**San Diego County Regional Airport Authority (SDCRAA)
Flight Procedure Evaluation
Citizen Advisory Committee Meeting #2**

San Diego International Airport

July 19, 2018

DRAFT Deliberative Document – For Discussion Purposes Only

ANAC Noise Recommendation 14 – Initial Review

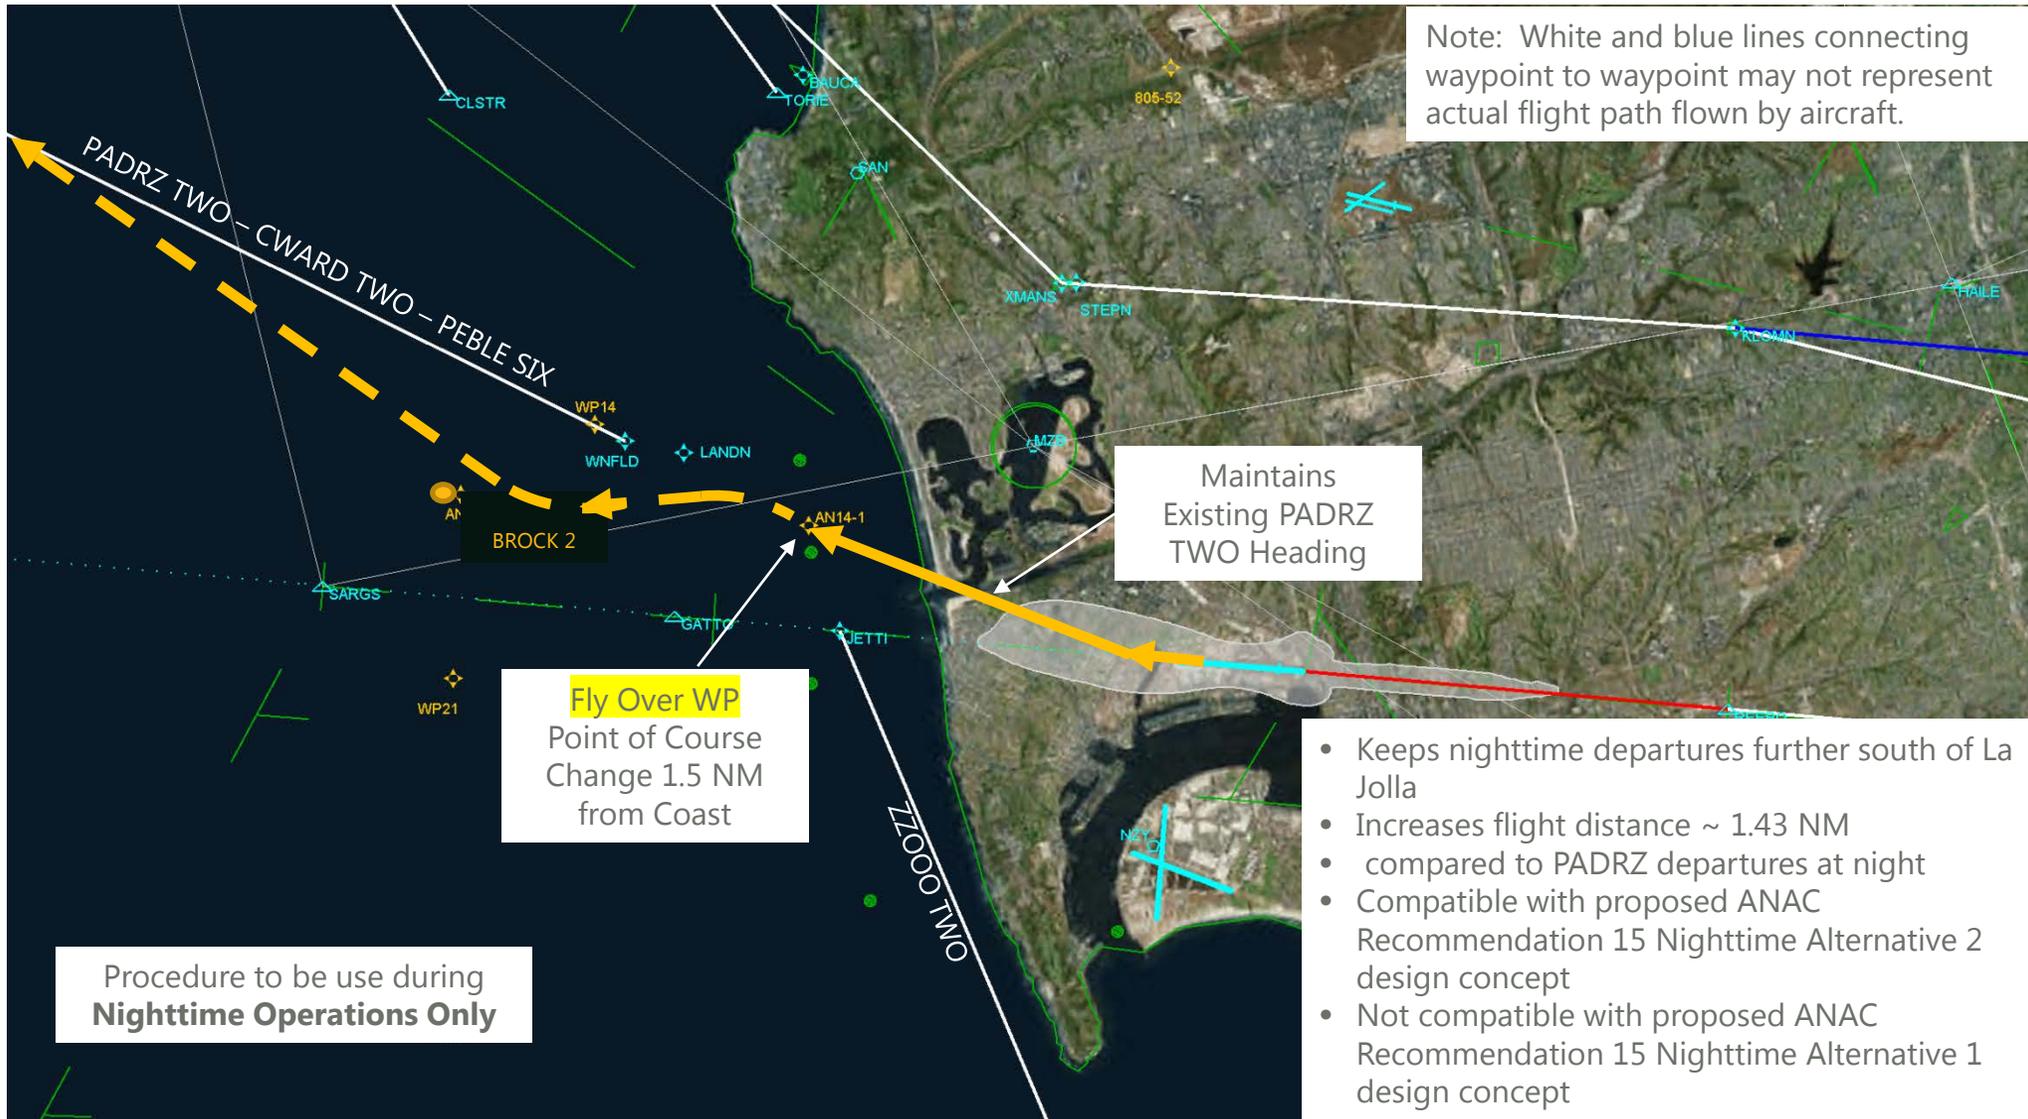
1. *Move LNDN and WNFLD waypoint south in line with Dot #2:*
 - The magnetic heading from the departure end of Runway 27 to Dot #2 is 287°, which is 12° from 275° heading. Moving LNDN and WNFLD waypoints south over Dot #2 would reduce the divergent angle below the required 15°. FAA Order 7110.65X allows for 10° divergence if both SIDS are RNAV, but would change initial runway heading and should be evaluated in the FAR Part 150 Study Update.

- Not feasible due to reduction in current divergent heading departure throughput capability. May be feasible if initial course from runway end is based on 10° divergence (285° heading). Change to initial heading design should be evaluated in FAR Part 150 Study

2. *Establish within the PADRZ SID procedure a horizontal distance from end of runway (1.0 NM miles) along a fixed heading which must be satisfied along with altitude before a right turn:* Change to initial heading design would be evaluated in FAR Part 150 Study

3. *Move WNFLD and KERNL waypoints 1.5 NM miles south of current location:*
 - If aircraft turn more westerly prior to reaching WNFLD, the divergence angle is no longer 15° ; therefore, the procedure must ensure aircraft heading south and north are laterally separated by 3 NM (note: FAA ATC applies an additional buffer between 0.5 to 1 NM to the 3 NM requirement)

- Assuming existing initial heading design, the earliest opportunity to turn west is north and east of WNFLD waypoint to ensure separation between ZZOOO SID and BORDER 7 SID

- Assuming a 10 degree divergent heading, WNFLD location may move south of existing location.

ANAC Noise Recommendation 14 – Alt 1 Turn at 1.5 NM

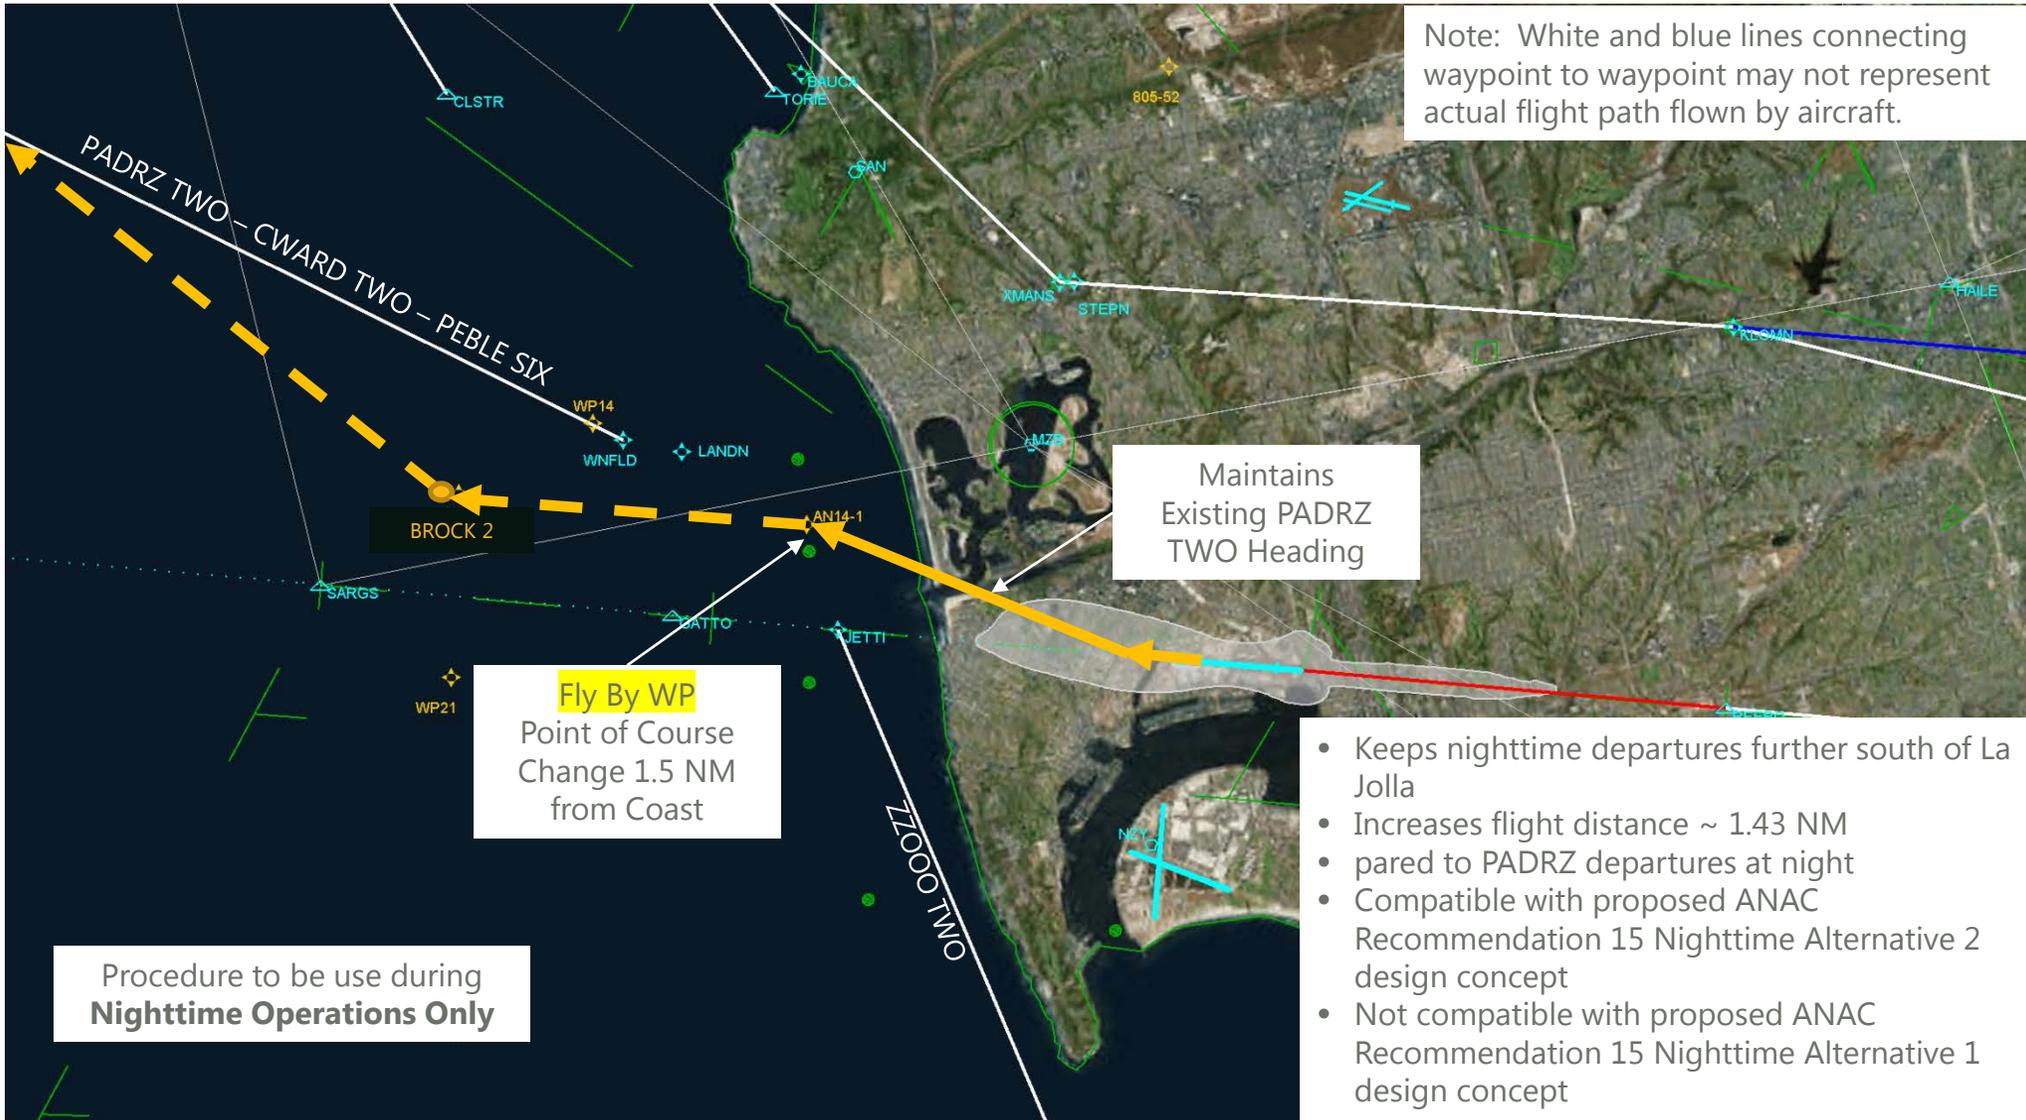
- Alternative 1 - Turn at 1.5 NM from shoreline
 - Maintains existing initial departure design (VA to DF leg coding)
 - Consistent with FAA Dot agreement

- Projected flight track on initial heading is consistent with current flight tracks
- Alternative 2 – Turn at shoreline
 - Maintains initial departure design (VA to DF leg coding)

ANAC Noise Recommendation 14 – Alt 2 Turn at Shoreline

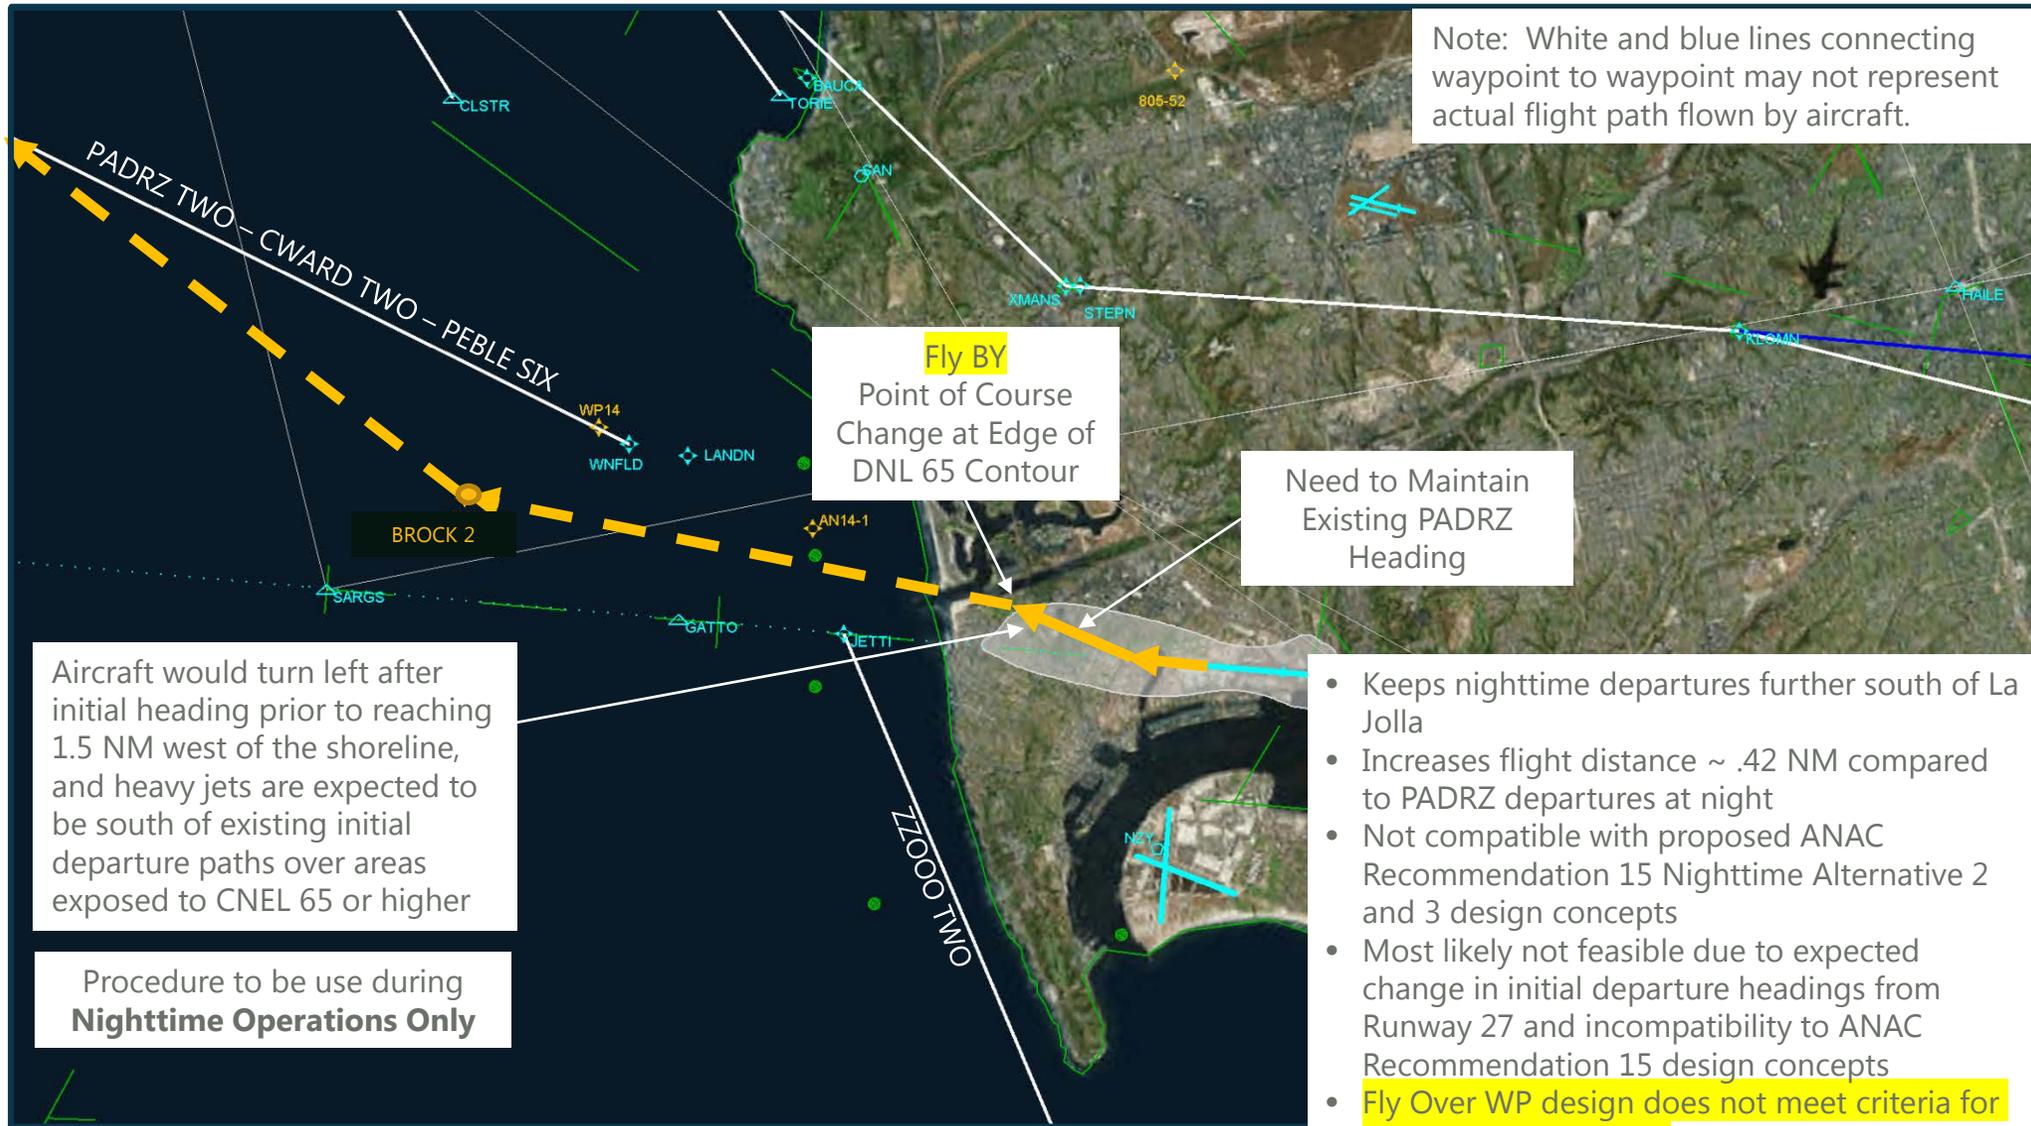
- Turn location prior to Noise Dot agreement
 - Projected flight track on initial heading is consistent with current flight tracks
- Alternative 3 – Turn at earliest point possible

ANAC Noise Recommendation 15 – Alt 1 Design

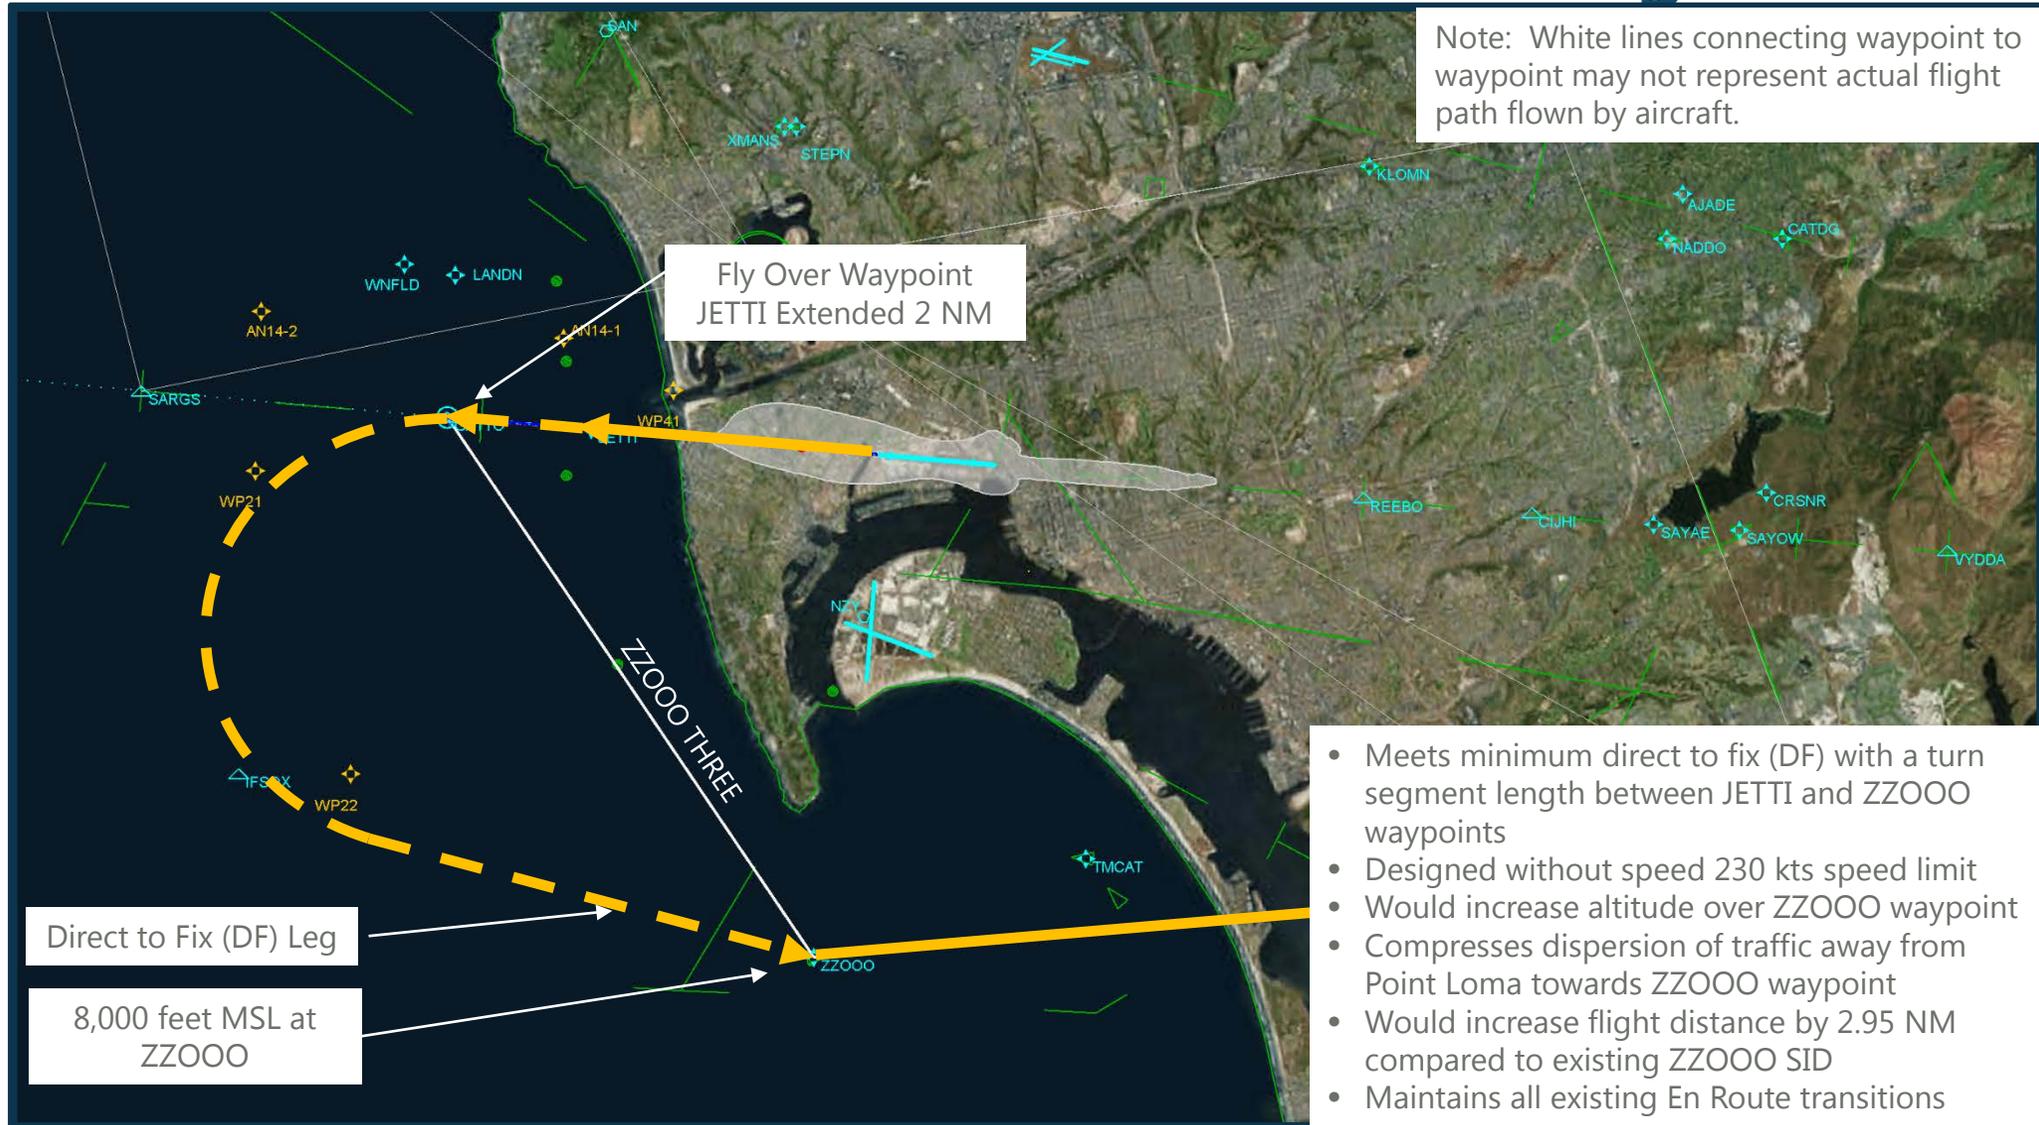
- Alternative 1
 - Moving JETTI further west may not result in an altitude increase if 230kt restriction is removed.
 - Turn radius following JETTI will vary more as compared today if 230kt speed restriction is eliminated

- What is expected benefit of having aircraft at or above 8,000 feet MSL near ZZOOO waypoint?
 - Can this be considered a nighttime alternative as well to help mitigate nighttime noise over Mission Beach?

- Prefer fly-over waypoint design (Point Loma representative)
- CAC: Alternative 1 - Can this design be considered as a nighttime departure procedure over Pt. Loma?
